ADDENDUM NO. 2

Venetia Valley TK-8 School Landscape Renovations

Project Number #25-03

Addendum Date: March 20, 2025

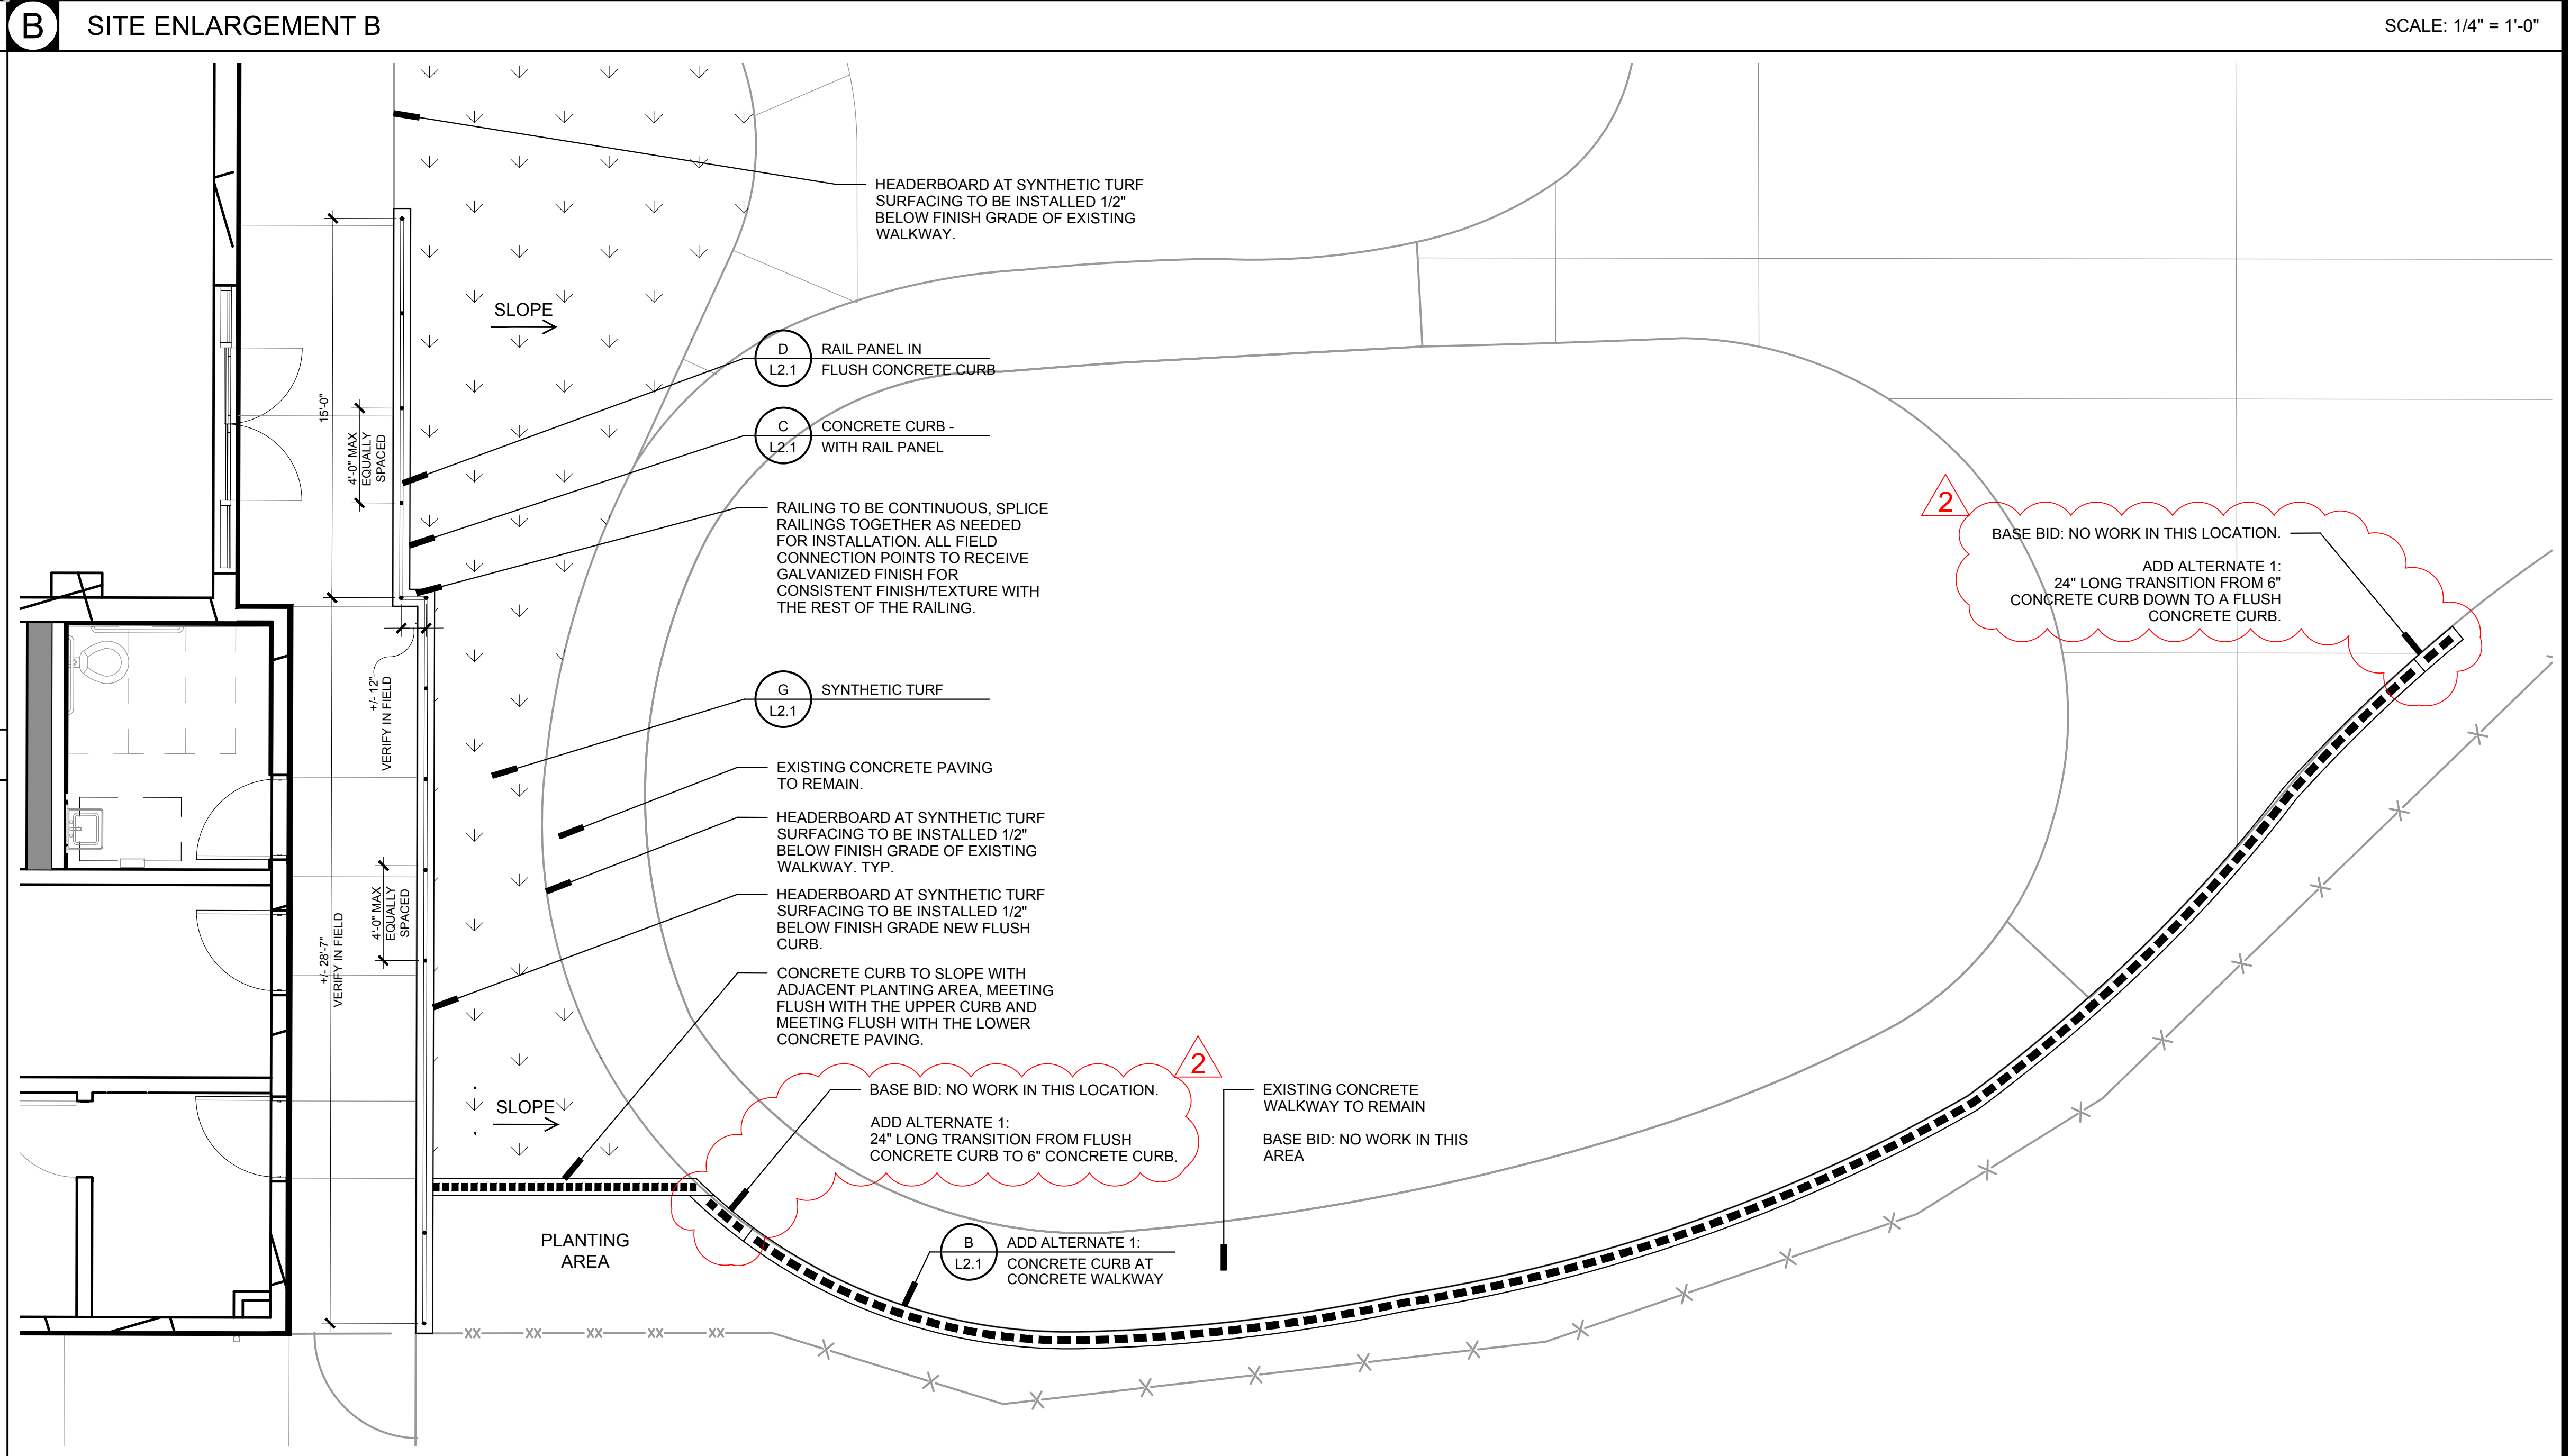
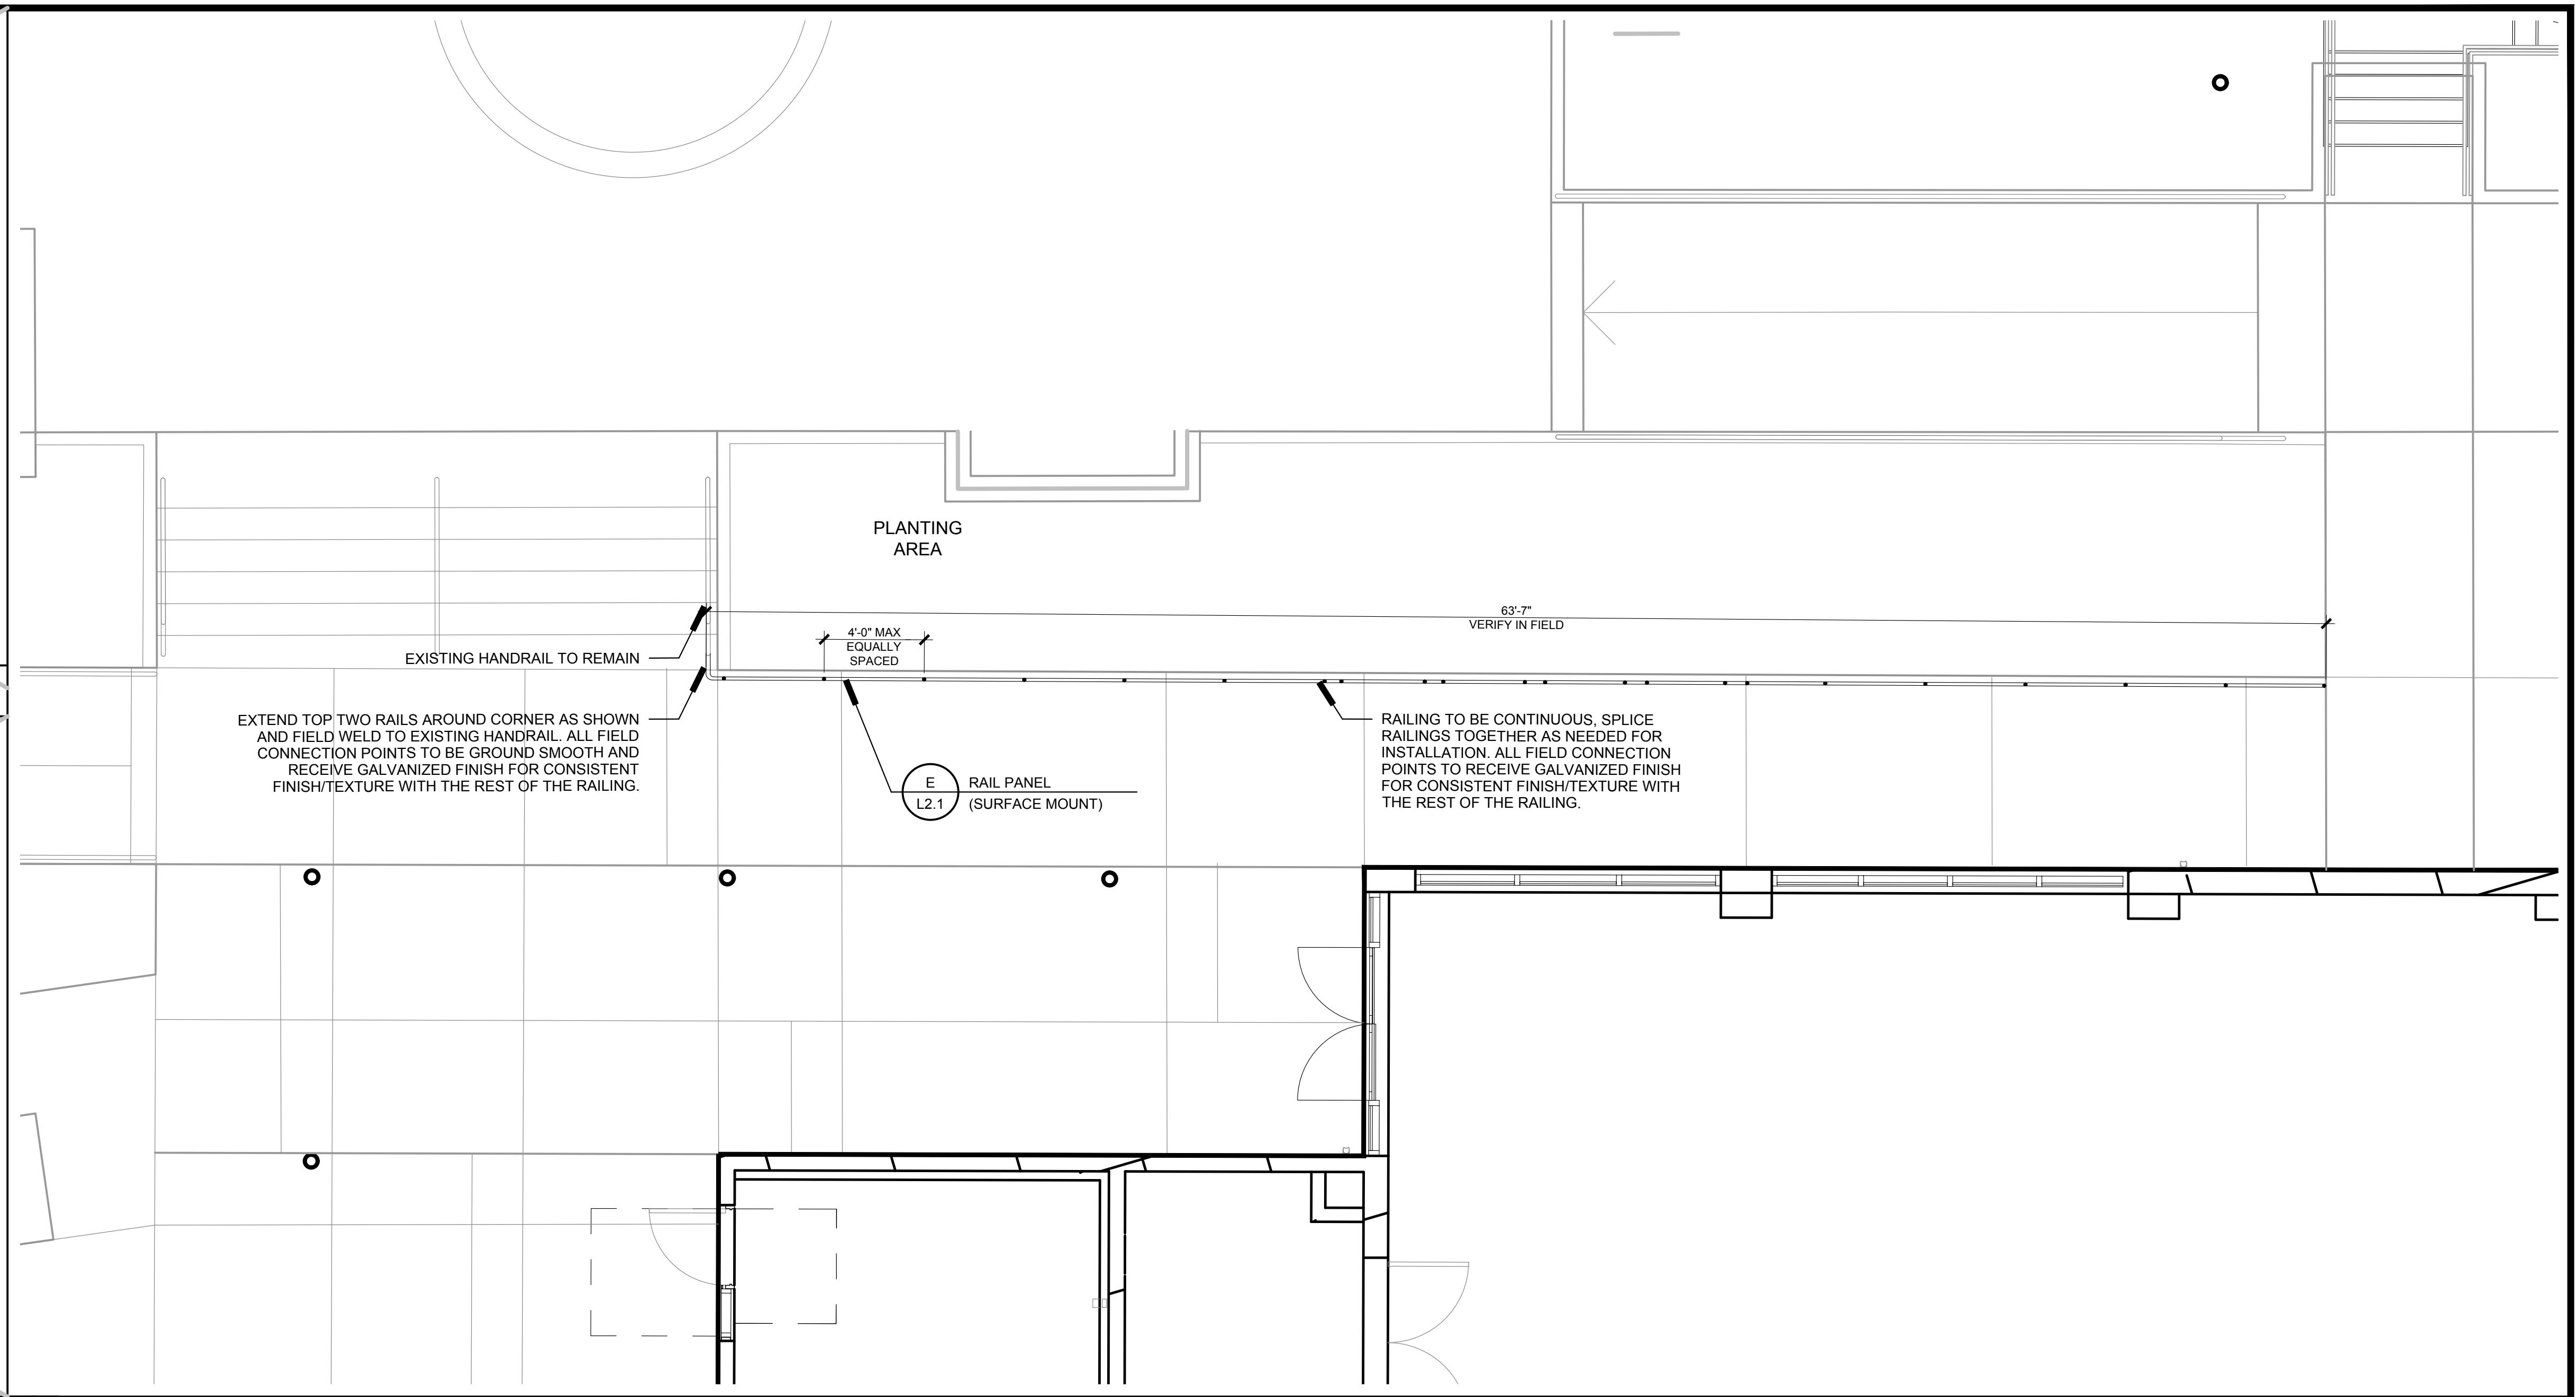
ITEM NO. 1.3: SHEET L2.2 CONSTRUCTION DETAILS:

Add: Callout to clarify scope of Base Bid versus Add Alternate 1 changes at concrete curb transition as shown on the attached sheet.

Replace: Sheet L2.2 in its entirety with the attached sheet Addendum 1-L2.2.
